Technical Service Information

THM 4T65-E

NEW DESIGN "PAWL" CLUTCH TYPE FREEWHEEL FOR INPUT AND THIRD

Figure 1

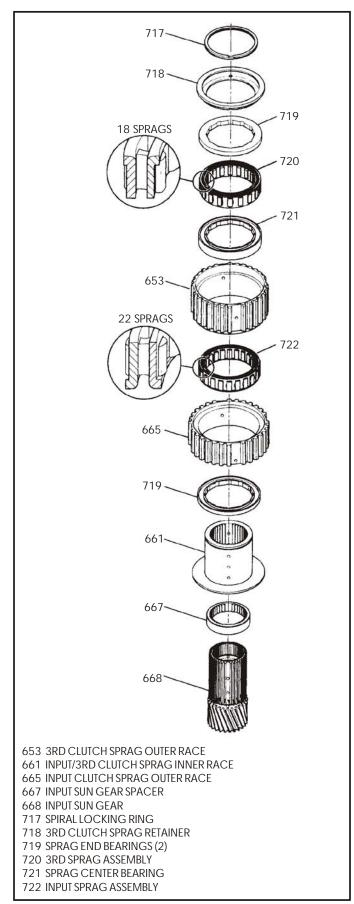
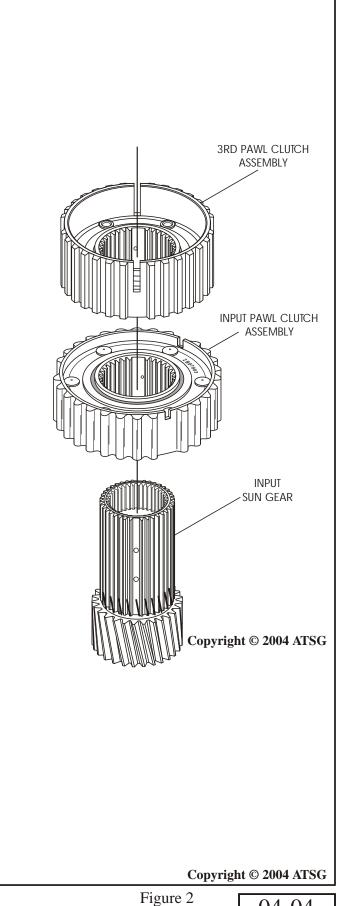
Some 2003 model THM 4T65-E transaxles will come equipped with a newly designed Input and Third "Pawl" Clutch Assembly instead of the previous design Input and Third Sprag Clutch, as shown in Figures 1 and 2. This was implemented at start of production for the 2003 model year.

- (1) INPUT "PAWL" CLUTCH The new design outer race has 30 splines instead of the previous 32 on the Input Sprag and cannot be disassembled like the previous design Sprag Clutch, which obviously makes the assembly process easier. Refer to Figures 1 and 2 for illustrations of both designs.
- (2) INPUT CLUTCH FIBER PLATE The new design fiber plate has 30 teeth instead of the previous design 32 teeth, to accommodate the new design "Pawl" Clutch Assembly. Refer to Figure 3 for illustrations of both designs.
- (3) THIRD "PAWL" CLUTCH The new design cannot be disassembled, like the previous design Sprag Clutch, which obviously makes the assembly process easier. Refer to Figures 1 and 2 for illustrations of both designs. The third clutch fiber plates remain the same as previous models.
